Rockwell service letter No. SL-AG-92

Service Letter No. SL-AG-92
6 May, 1977

CARBURETOR AIR TEMPERATURE INDICATOR AND IMPROVED EXHAUST SYSTEM INSTALLATION

MODELS AFFECTED: S-2R, S/N 5000 thru 5083.

Figure 1.

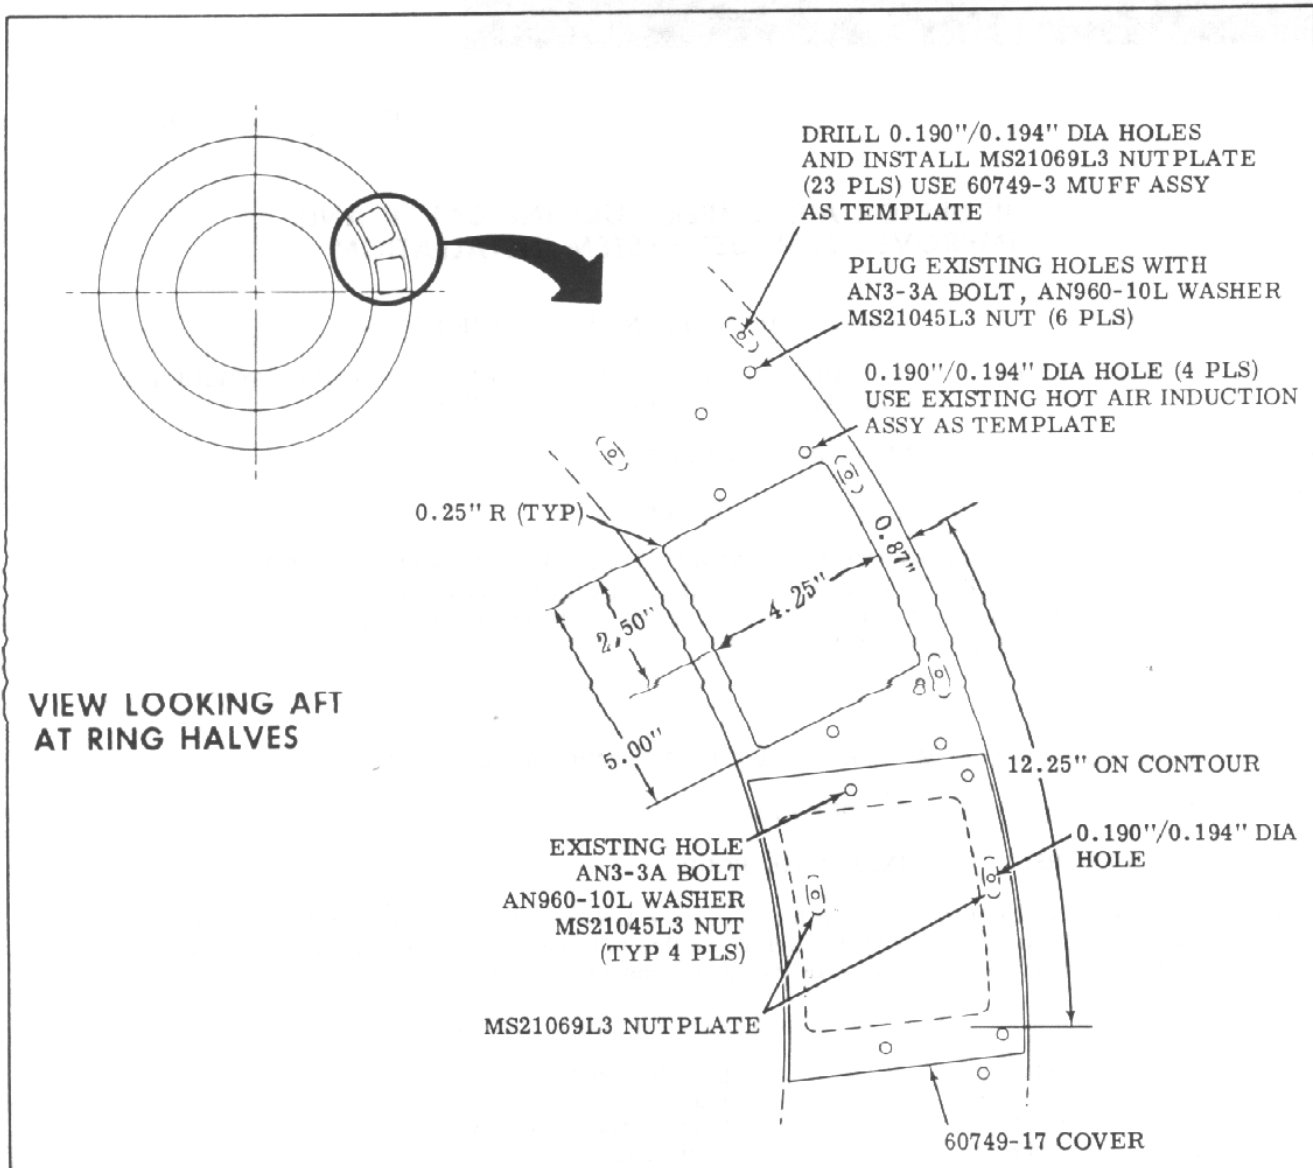
9. Drill and install MS21069L3 nutplate on 60749-17 cover with MS20426AD3 rivet (see Figure 1).
10. Install 60749-17 cover on forward side of left ring half over existing cutout picking up existing holes (see Figure 1).
11. Drill through remaining hole in 60749-17 cover assembly and through ring half and install MS21069L3 nutplate on ring half with MS20426AD3 rivet (see Figure 1).
12. Plug existing open holes on ring halves with AN3-3A bolt, AN960-10L washer and MS21045L3 nut (see Figure 1).
13. Locate and make a 4.25" x 5.00" cutout in left ring half for hot air induction assembly (see Figure 1).
14. Locate and drill 0.192 (\pm 0.002) inch diameter hole (23 places) on existing ring halves for installation of 60749-3 muff assembly. Use 60749-3 muff assembly for template (see Figure 1).

Trim upper and lower angles of 60749-3 muff assembly, as necessary, to clear bolt heads installed in step 12.

15. Drill and install MS21069L3 nutplate (23 places) on ring halves with MS20426AD3 rivets (see Figure 1).
16. Locate and drill 0.192 (\pm 0.002) inch diameter hole (4 places) in left ring to match attached holes in existing hot air induction assembly (see Figure 1).

Figure 2

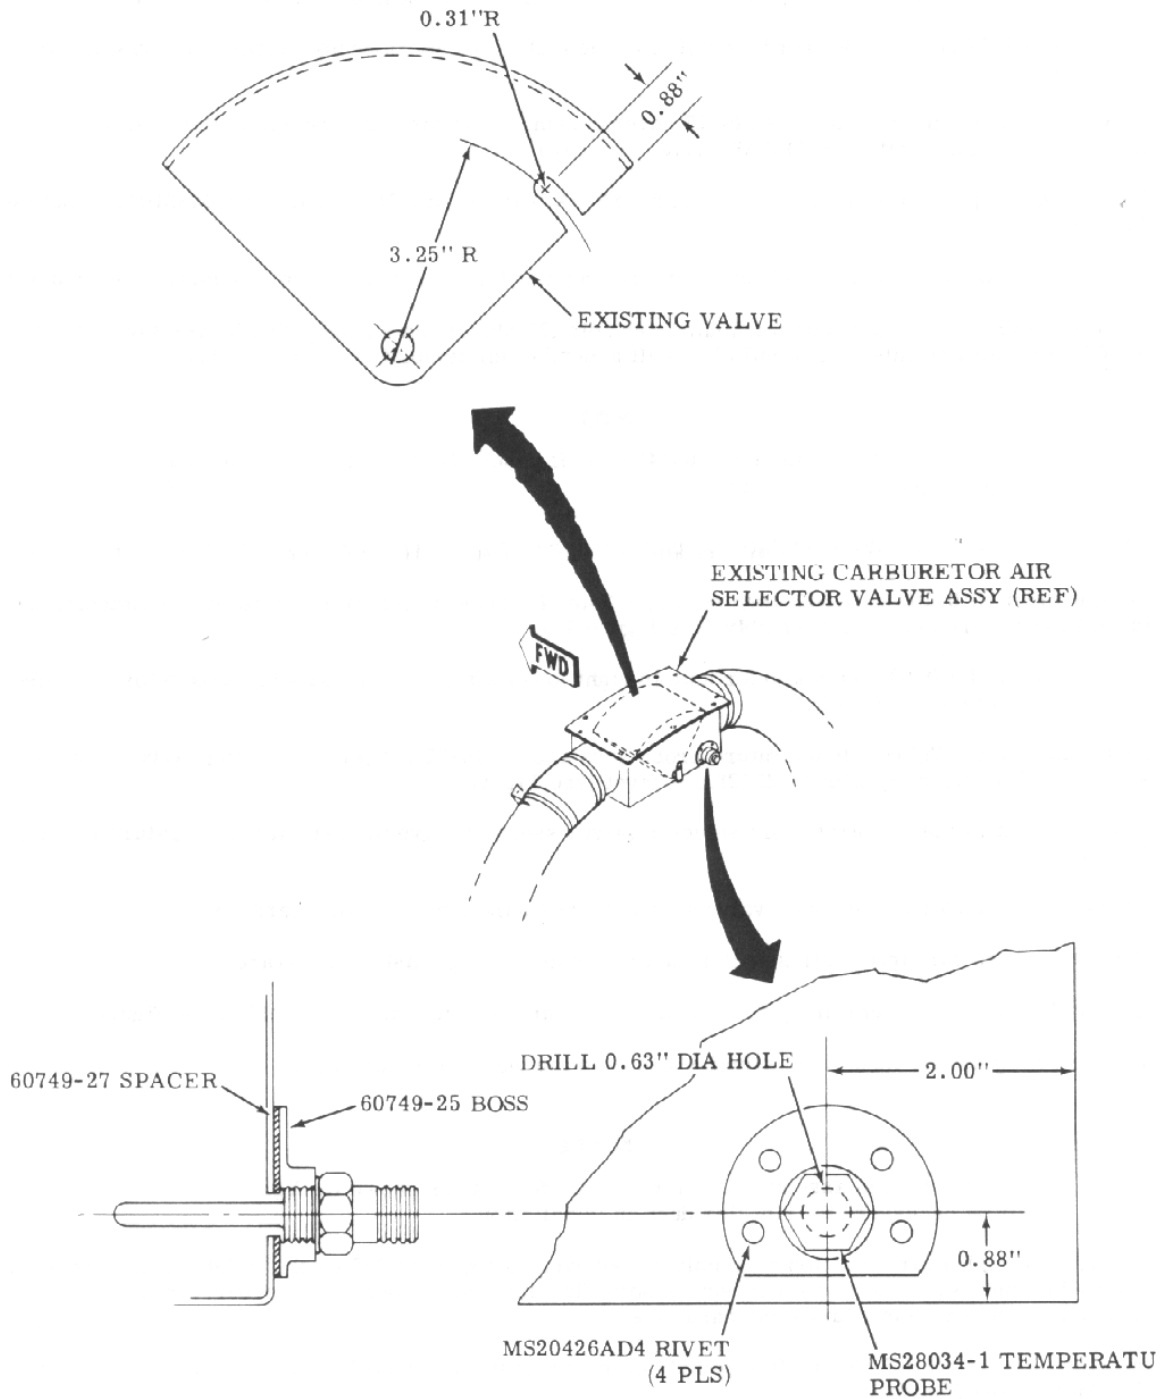
17. Locate and drill a 0.63 inch diameter hole in right lower aft corner of existing carburetor air selector valve assembly (see Figure 2).
18. Drill and install 60749-25 temperature probe boss and 60749-27 spacer on existing carburetor air selector valve assembly with MS20426AD4 rivet (see Figure 2).

19. Make a cutout in the carburetor air selector valve assembly valve to clear air temperature probe (see Figure 2).
20. Reinstall carburetor air selector valve assembly on engine using existing hardware.

21. Reinstall top on carburetor air selector valve assembly using existing hardware.
22. Install MS28034-1 temperature probe on carburetor air selector valve assembly (see Figure 2).

Figure 3.

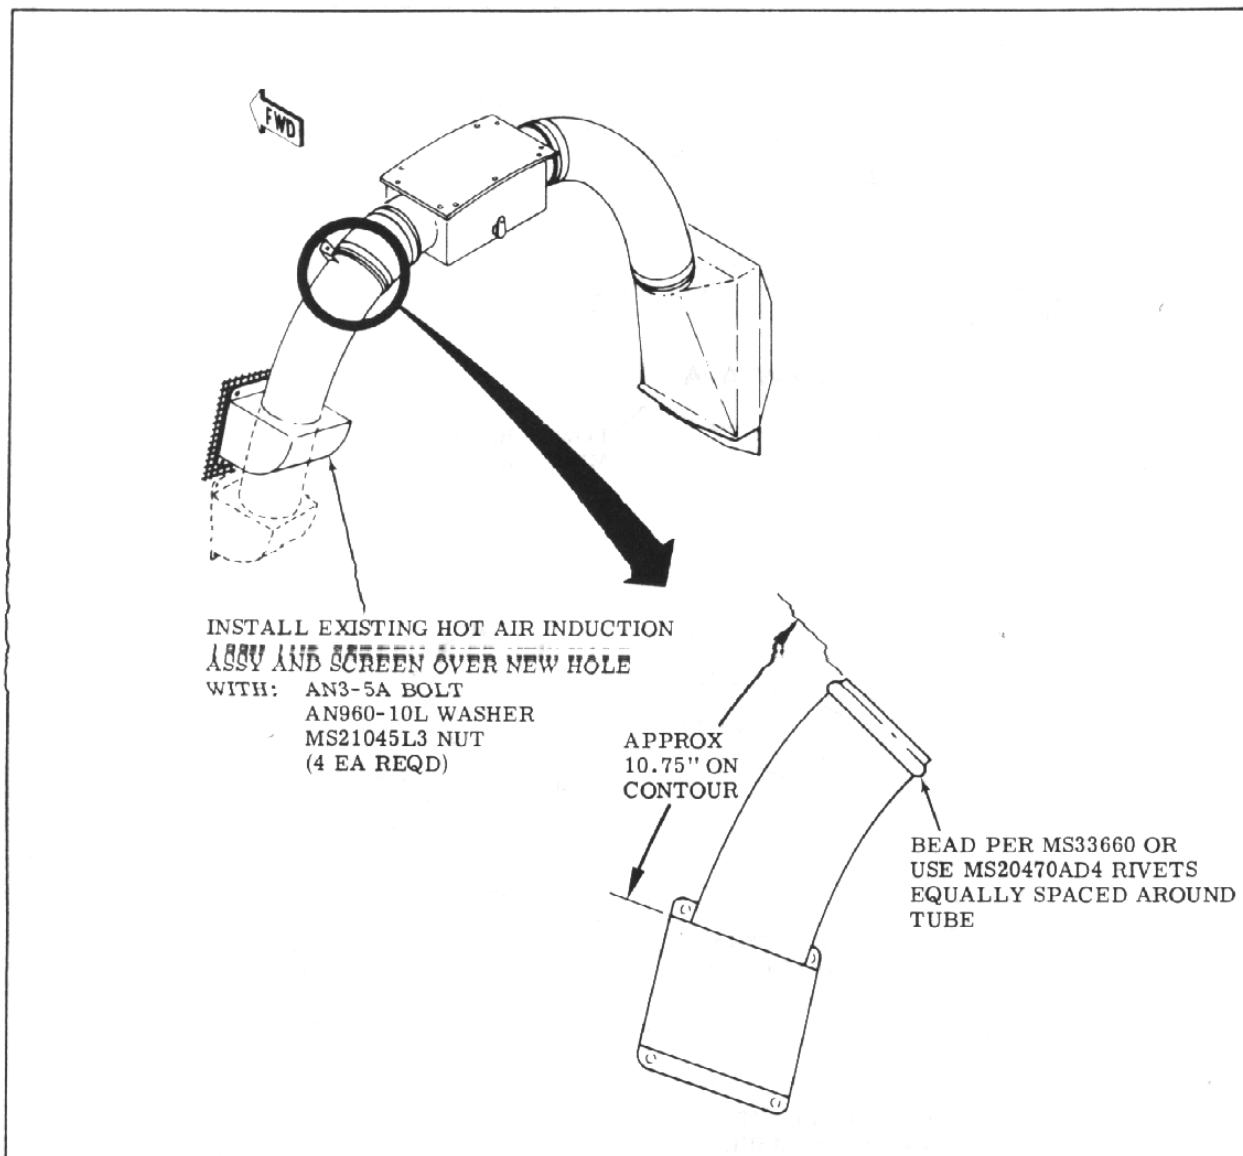
23. Trim existing hot air induction assembly and bead the end (see Figure 3).

If hot air induction assembly is shorter than dimensions shown in Figure 3, it will be necessary to trim flex duct on installation.

Figure 4.

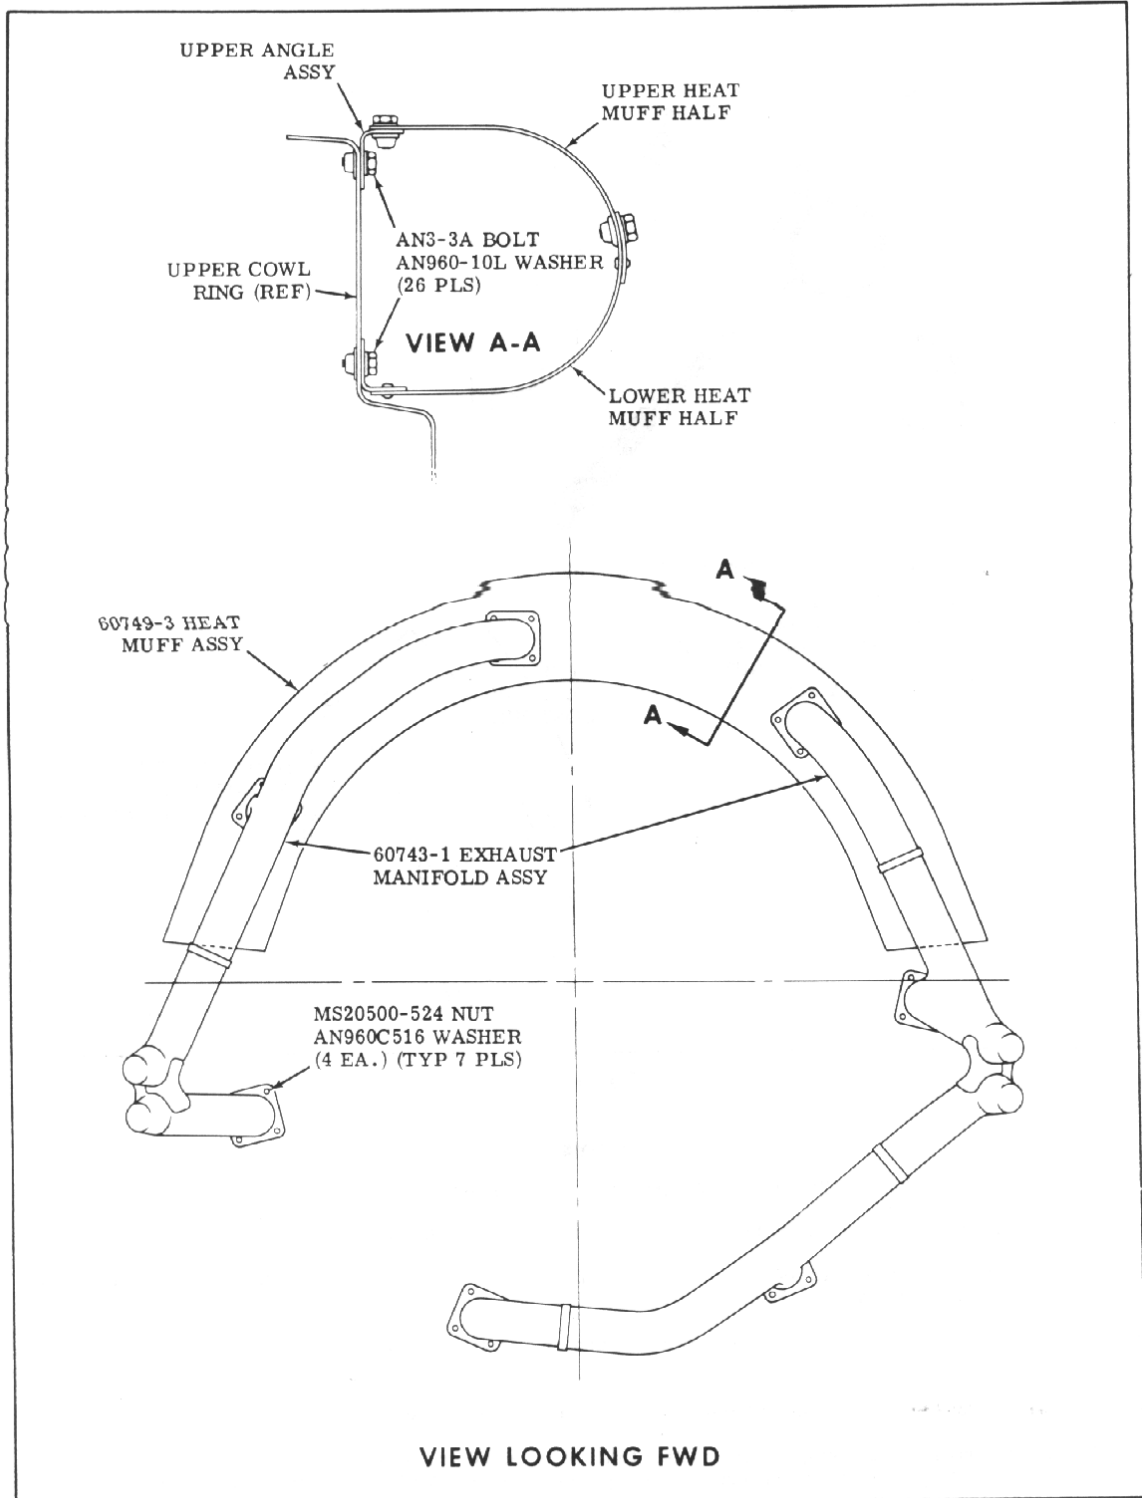
24. Install existing hot air induction assembly on left ring half with AN3-5A bolt, AN960-10L washer and MS21045L3 nut (4 places) and reconnect existing flex ducts and controls on carburetor air selector valve assembly using existing clamps and hardware.
25. Install lower half of 60749-3 muff assembly on ring halves with AN3-3A bolt and AN960-10L washer (12 places) (see Figure 4).
26. Install heat muff upper angle assembly on ring halves with AN3-3A bolt and AN960-10L washer (14 places) (see Figure 4).
27. Install 60743-1 exhaust manifold assembly on engine with MS20500-524 nut and AN960C516 washer (28 places)(see Figure 4).

28. Install upper half of muff assembly using hardware furnished with muss assembly (see Figure 4).
29. Locate and make cutouts in left instrument panel for 0201-009 carburetor air temperature indicator and 20-0304-B-24 post light (see Figure 5).
30. Install 0201-009 carburetor air temperature indicator on left instrument panel with MS28042-3A clamp (see Figure 5).
31. Install 20-0304-B-24 post light on left instrument panel (see Figure 5).

Figure 6.

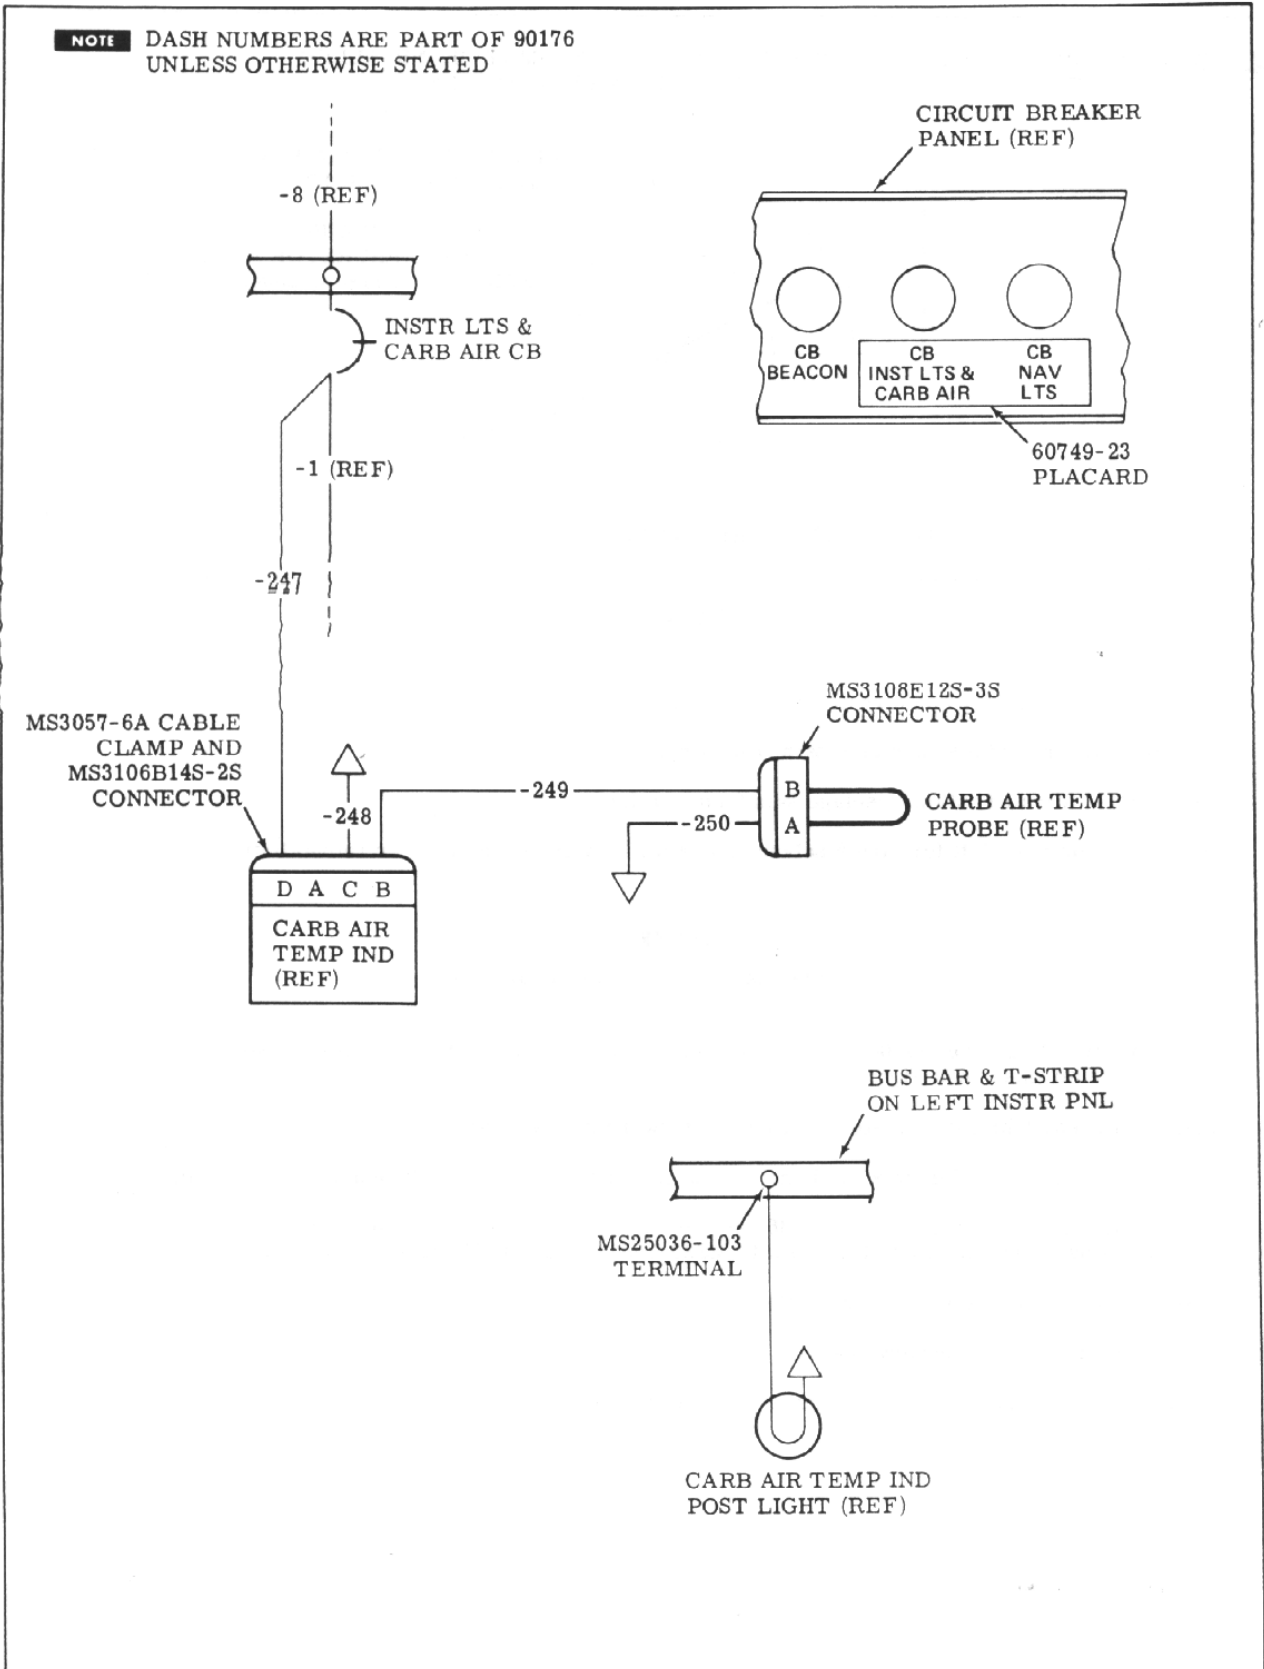
32. Connect carburetor air temperature system to airplane electrical system with 90176-247, -248, -249 and -250 wires, MS3108E12S-3S connector (on temperature probe), MS3057-6A cable clamp and MS3106B14S2S connector (on carburetor air temperature indicator) (see Figure 6).

33. Install 60749-23 placard on circuit breaker panel (see Figure 6).
34. Remove left forward fuselage side from airplane.
35. Remove left forward bottom fuselage skin from airplane.
36. Remove scoop from left forward fuselage side skin. Retain scoop for later reinstallation.

Figure 7.

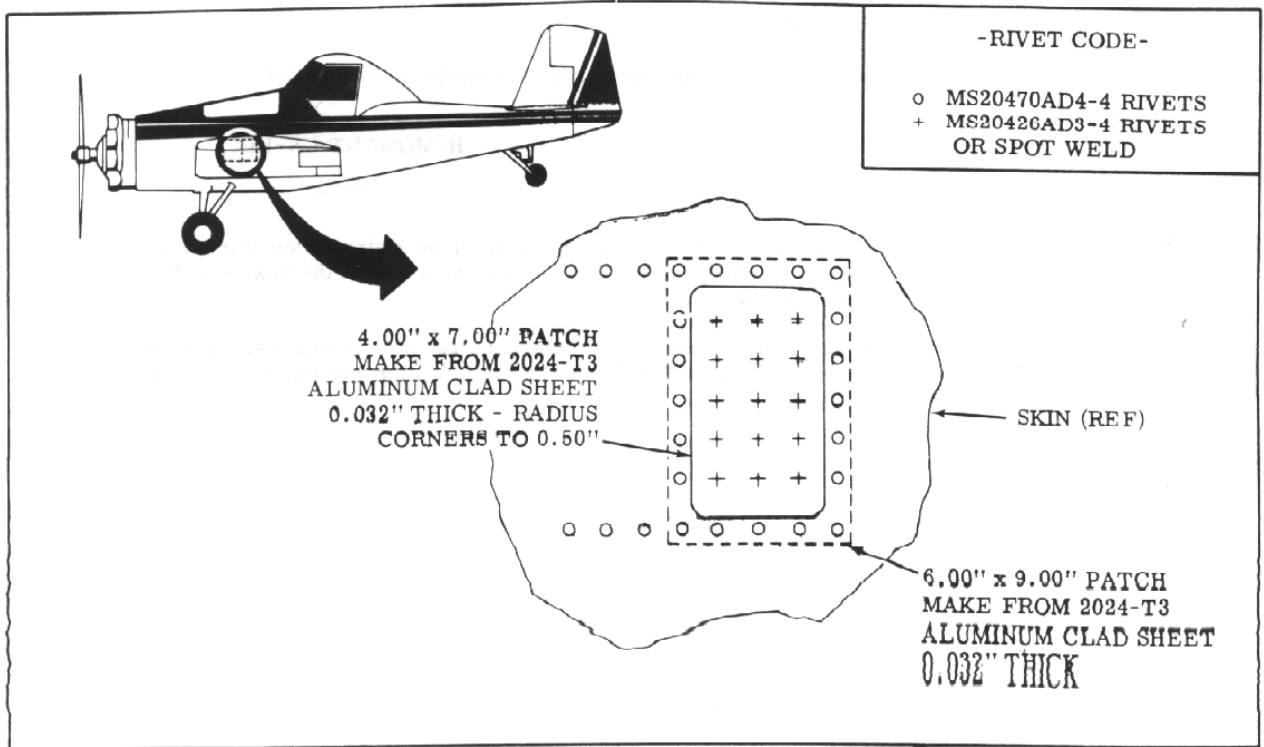
37. Fabricate two (2) patches (6.00 inch x 9.00 inch and 4.00 inch x 7.00 inch) from 0.032, 2024-T3 aluminum clad sheet (see Figure 7).
38. Install patches, fabricated in step 37., on left forward fuselage side skin (see Figure 7).
39. Locate and make a 4.00 inch x 7.00 inch cutout in left forward bottom fuselage skin (see Figure 8).
40. Using existing scoop removed in step 36 as a template, locate and drill attaching holes in left forward bottom fuselage skin and install scoop with MS20470AD4-4 rivet (17 places)(see Figure 8).
41. Install modified fuselage skins on airplane.
42. Reinstall all engine accessory cowling.
43. Install 50175-563 placard on instrument panel near carburetor air temperature indicator.
